Environmental Assessment

S75W Application to modify approved layout and staging of Awaba Waste Management Facility - Project Approval (Consolidated) 10_0139

Report: MOD 1 – 29 April 2014

Project: Awaba Waste Management Facility Expansion Project

Figure 2 – existing approved plan (appendix 3) showing the proposed location of the diversion structure.

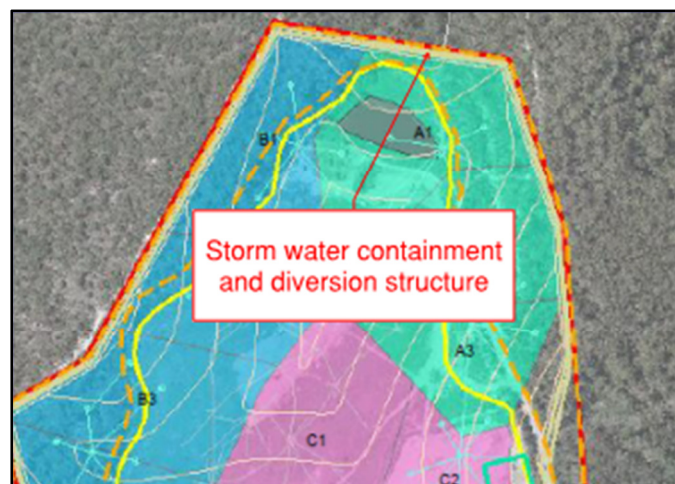
The proposed modification includes the addition of an in-situ concrete containment and diversion structure to be constructed at the northern boundary of the site within the 10 metre boundary setback, to prevent the mixing of off-site clean water overland flows with on-site leachate management.

3-dimesional modelling of the proposed expansion of the landfill and its final profile indicated that clean-water run-off from an area north of the site boundary, approximately 1000m² in footprint, would be trapped in a basin formed by the natural

contours north of the site boundary and the final contours of the proposed landfill extension.

It is proposed that a containment and diversion structure be constructed immediately adjacent the northern side boundary and within the proposed 10m on-site boundary setback to divert clean water from entering the site.

The planned structure will likely have a height of less than two metres and be constructed along a section of the northern boundary to divert clean water around the site.

The clean water run-off captured from the off-site area north of the boundary will be conveyed by gravity through a suitably sized drain for discharge through an energy-dissipating structure along the eastern perimeter of the site.

Figure 3 – existing approved plan (appendix 3) showing location of sediment basin. Note design contours run through this area. However, the area is excluded in error from the landfilling staging plan.

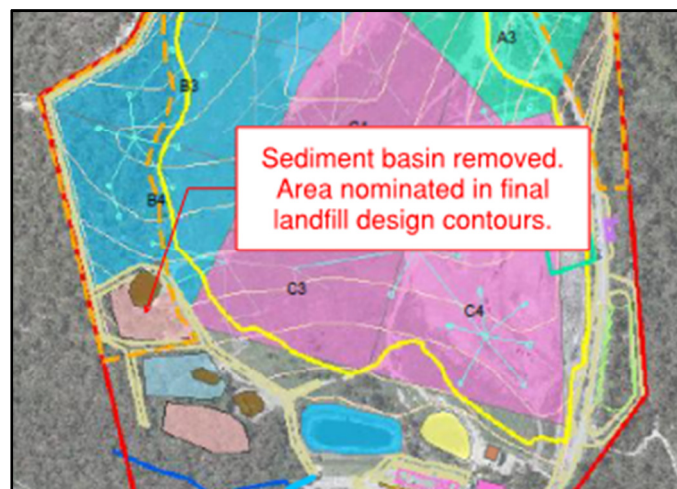
Appendix 3 –key components of the proposed expansion, of the approved plans, shows a sediment basin to be retained and extended at the south west boundary of the site.

Under the current approved plans, the location of the basin is excluded from the proposed footprint of landfilling during stage B4, this is inconsistent with the proposed landfill concept for the site, assessed under the Environment Assessment for the project.

The planned sediment basin is required during the initial stages of development on-site, however the basin will not be required for stormwater management during the later stages of landfilling.

During this latter period, it is proposed that the basin be decommissioned and incorporated into the final landfill footprint. This change is consistent with the approved extent of excavation and the contours for the proposed emplacement as shown at current approved plans (Appendix 3 and 6) that show this area being within the planned footprint of the landfill.

The inconsistency in the plans exist where the sediment pond shown in appendix 3 - key components of the proposed expansion, is not shown as temporary and therefore excluded in the area of landfilling known as 'B4', as currently shown at the approved staging plan. As a result this area is omitted from the final landfill footprint. Notwithstanding the approved design contours of the final landfill cap are shown in this area. The omission of the area from the landfill staging plan is a plan drafting error.

Figure 4 – extract from proposed plans contained within original Environmental Assessment that show the basin as temporary with the final landfill design contours overlaid.

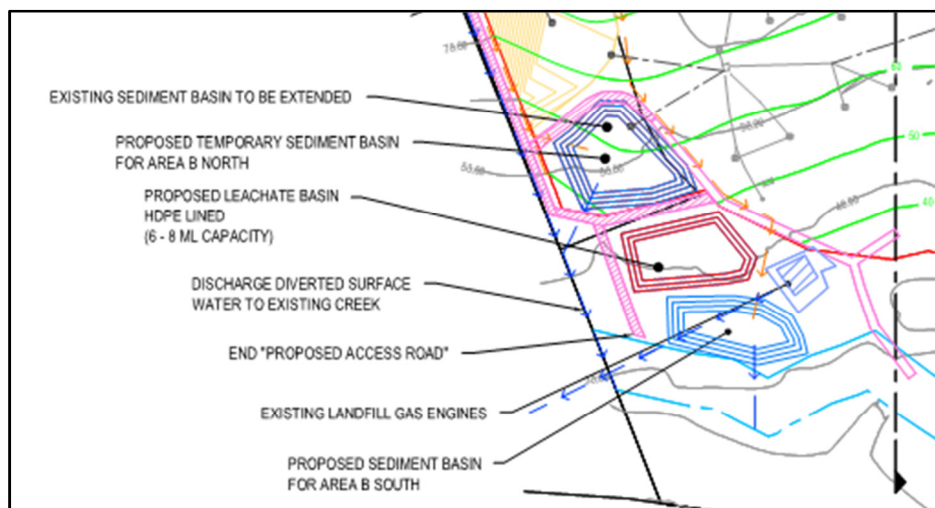
As it can be seen within the Environmental Assessment, the footprint as detailed in volume 2 appendix D GHD drawing SK013 revision C, as partially shown below at figure 4, details final landfill design contours and therefore the landfill footprint over the area that was omitted from the approved staging plan.

This proposed modification will correct an error in the approved plans.

Figure 5 – approved staging plan as shown at Appendix 4.

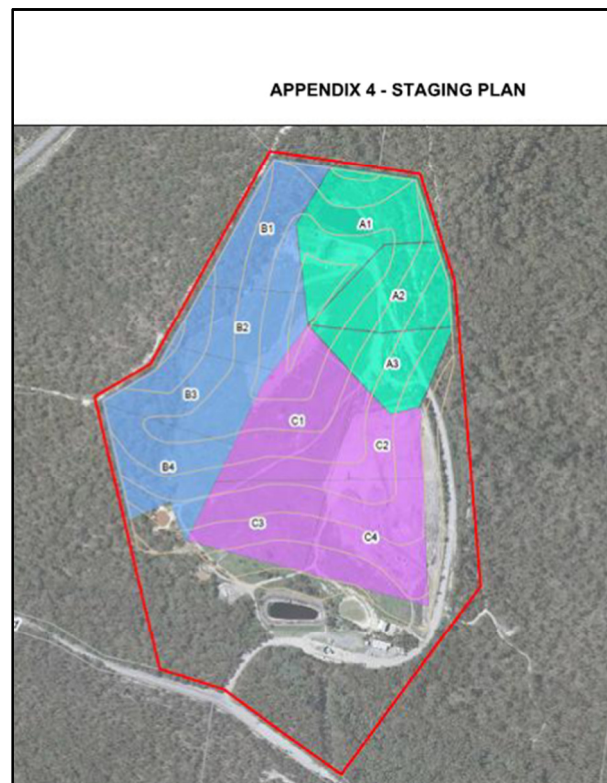
Approved plan Appendix 4 –staging plan, shows the approved stages of landfilling as shown below at figure 5.

During the detailed design phase, it has been established that the approved staging plan is not considered the best means of constructing and operating the landfill.

The proposed staging plan is preferred to the approved staging plan as the modified scheme:

- is designed to prevent the construction of undesirably large lined areas ahead of landfilling, which may lead to excessive exposure of landfill liner to UV radiation and weathering and the capture of stormwater;

- minimises the working cell area through the life of the landfill, significantly decreasing the overall volume of leachate generated throughout the life of the landfill;

- provides more appropriately shaped cells to allow for more symmetry and hence control of the working tip face to minimise the quantity of exposed waste at any point in time. This will minimise odours and vermin attraction; and,

- the updated staging plan better facilitates progressive capping and rehabilitation of the landfill by planning smaller stages prior to completion, capping and rehabilitation. This will minimise leachate generation, improve surface water quality, minimise odours and improve visual amenity.

The landfill will be filled in a systematic manner, as required by Condition 7(d) with nine cells instead of eleven as previously proposed, but in five construction stages instead of three as originally approved.

In this regard, it is recommended that the staging of landfilling be modified from three large stages A, B and C (11 cells) to the construction of five smaller construction stages (9 cells).

LAKE MACQUARIE CITY COUNCIL
AWABA WASTE MANAGEMENT FACILITY
STORMWATER AND GROUNDWATER
MANAGEMENT INFRASTRUCTURE

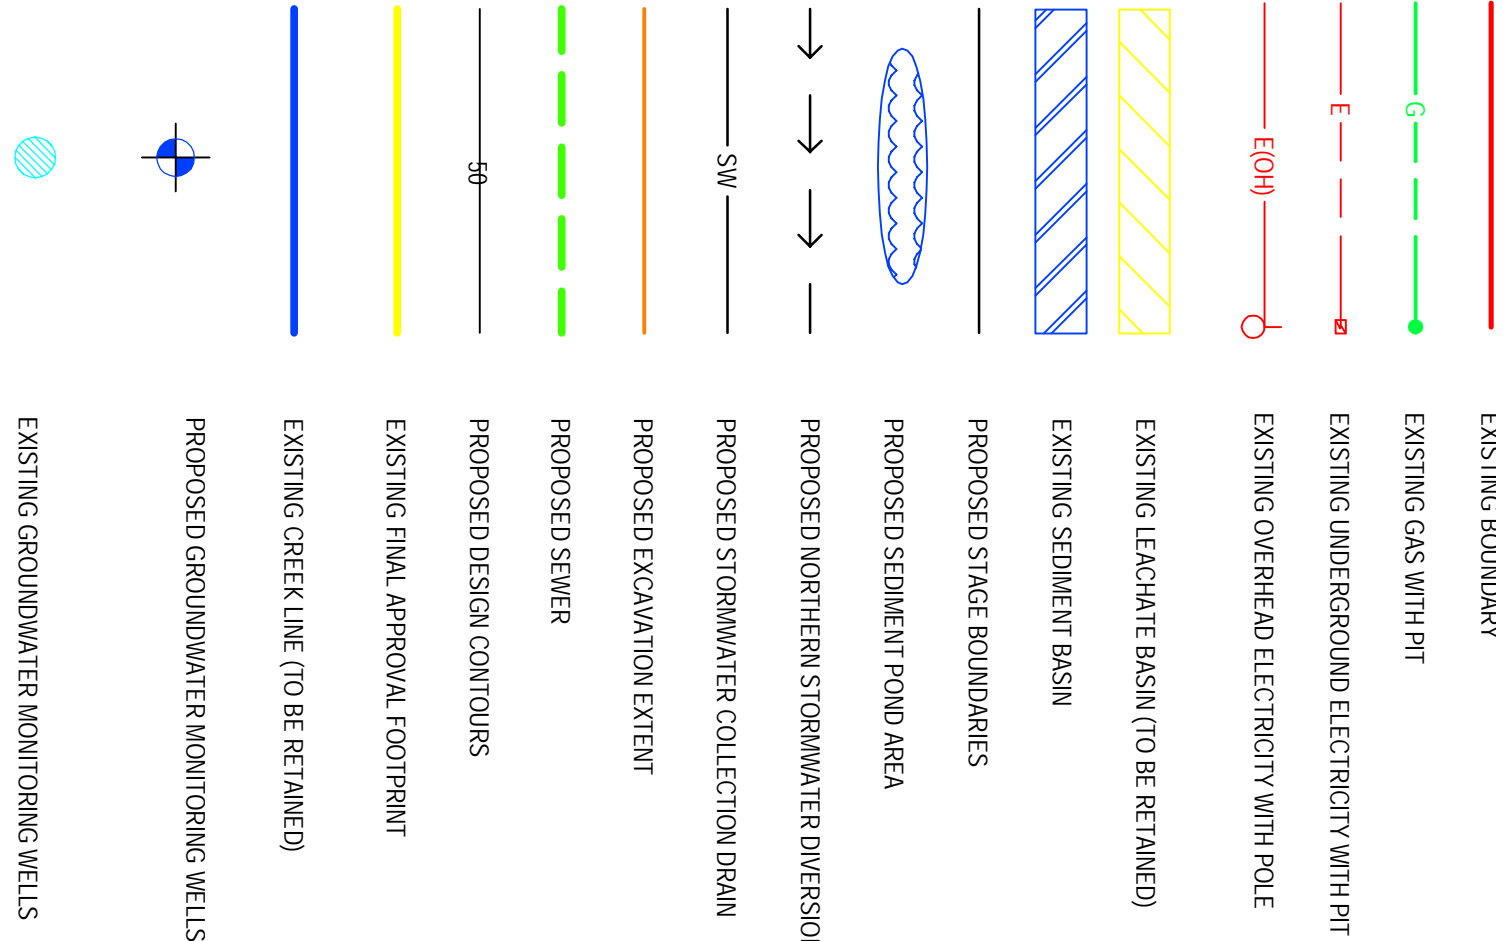
The modified plans at Appendix 1 show the removal of the structure at new plans SK062 rev A dated 19.12.13 by GHD Job.No.22-16920 –stormwater and groundwater management infrastructure.

New plan SK62 – *Stormwater and Groundwater Management Infrastructure*, shows the planned stormwater flows resulting from the proposed addition of the diversion and containment structure and connection to the proposed stormwater collection drains. 'For construction' details of the stormwater management scheme inclusive of the proposed structure, can be finalised with the submission of information as required at Condition 19 – Soil, Water and Leachate Management Plan.

COMPONENTS OF PROPOSED WORKS

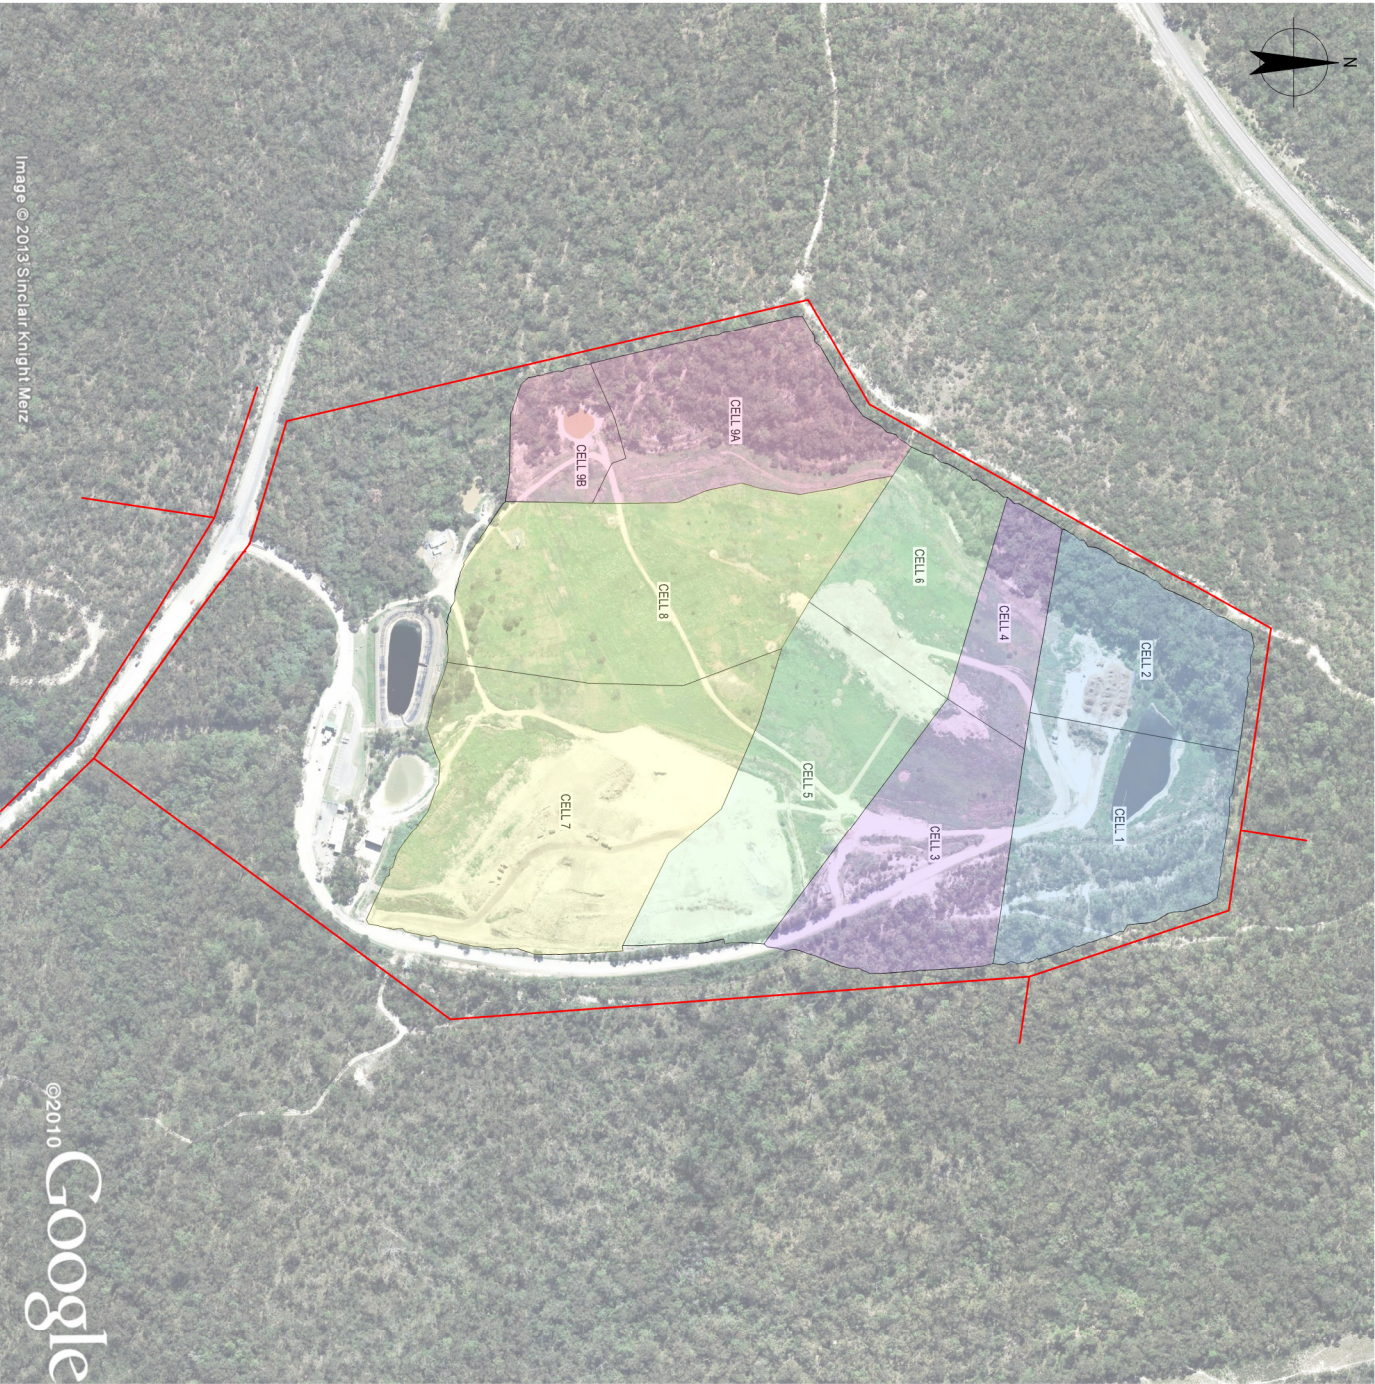
The proposed structure is shown at new plans SK060 rev A dated 19.12.13 – components of proposed works and SK062 rev A dated 19.12.13 – *Stormwater and Groundwater Management Infrastructure* by GHD Job.No.22-16920.
